ADDENDUM # 2

June 2, 2021

Administration and Training Center
for
Tri-County Board of Recovery and Mental Health Services
1280 N County Rd. 25a
Troy, Ohio 45373
Project #1615.04

ITEM 2 **DRAWINGS, Sheet T1.01 First Floor Technology Plan**

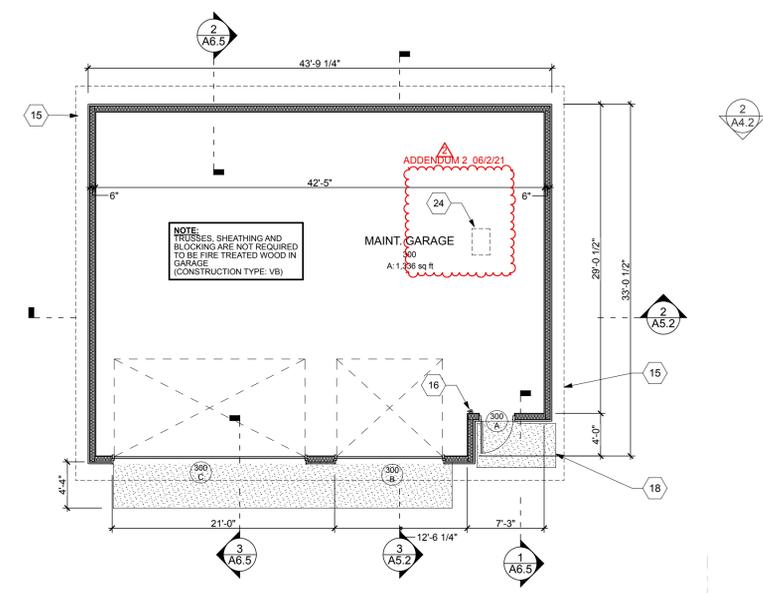
A. Provide one (1) delta “2D” in the following rooms: Record Storage 119 and 122, IT Workroom 104, and Serving 150, refer to Architectural Plan for room names and numbers. Verify location in room with Architect.

B. Provide one (1) vertical rack in IT Workroom 104. Confirm location with Owner and Architect. Dashed lines indicate potential future racks/access space.

REVISIONS FOR REBID	
ADDENDUM 1	5/25/2021
ADDENDUM 2	6/2/2021
COMM. NUMBER	DATE
1615.04	05/12/21
DRAWN BY	CHECKED BY
AF	DF
GARAGE AND AHU PLAN	
A2.2

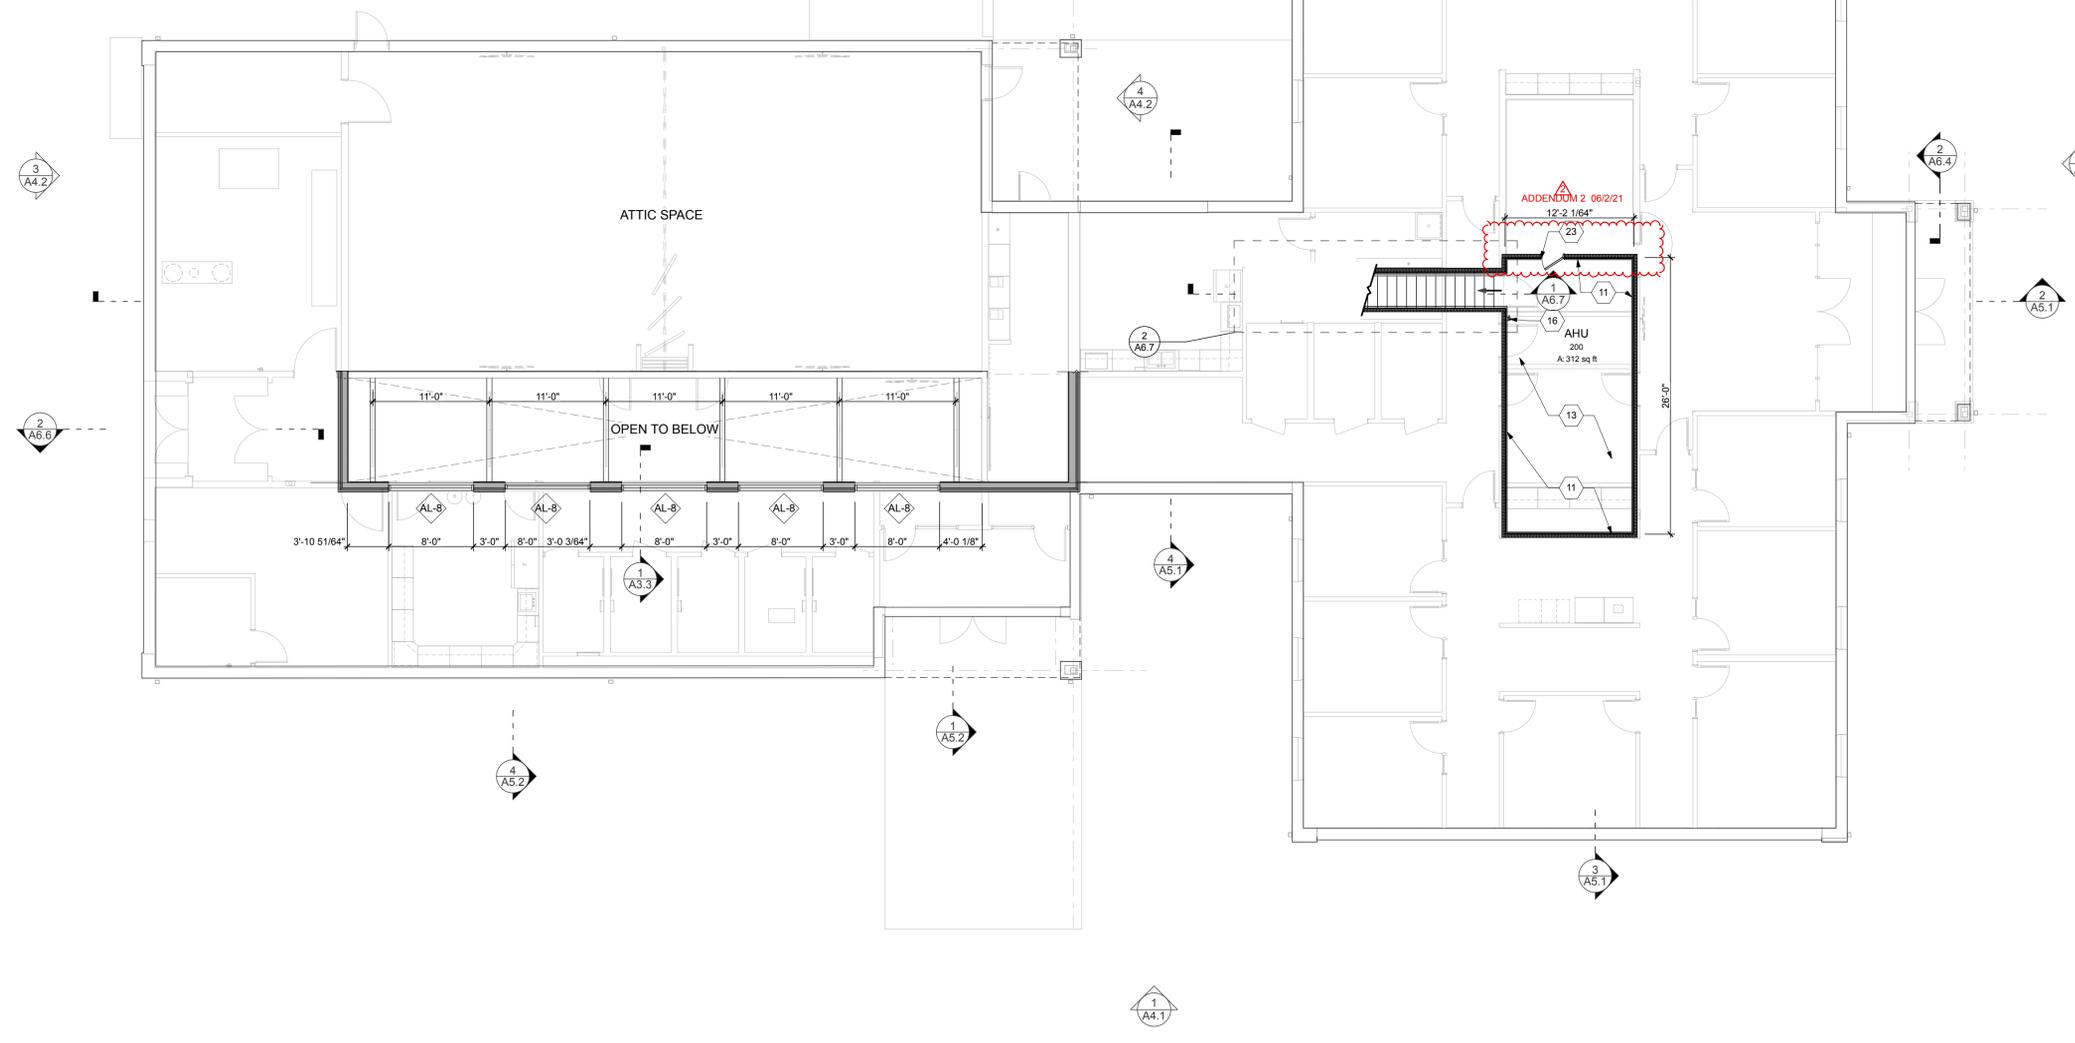
ITEM 1 **DRAWINGS, Sheet A2.2 Garage and AHU plan, and A10.1 Reflected Ceiling Plan**

A. Attic access panels have been added. Replace Sheets A2.2 & A10.1 with drawings included in this addendum.

- 24 20"x30" ATTIC ACCESS PANEL. BASIS OF DESIGN: NYSTROM NON RATED 16 GA STEEL DOOR/FRAME WITH 1" EXPOSED FLANGE SCREW DRIVER CAM LOCK. WHITE POWDER COAT FINISH. COORDINATE LOCATION WITH MEP SYSTEMS.
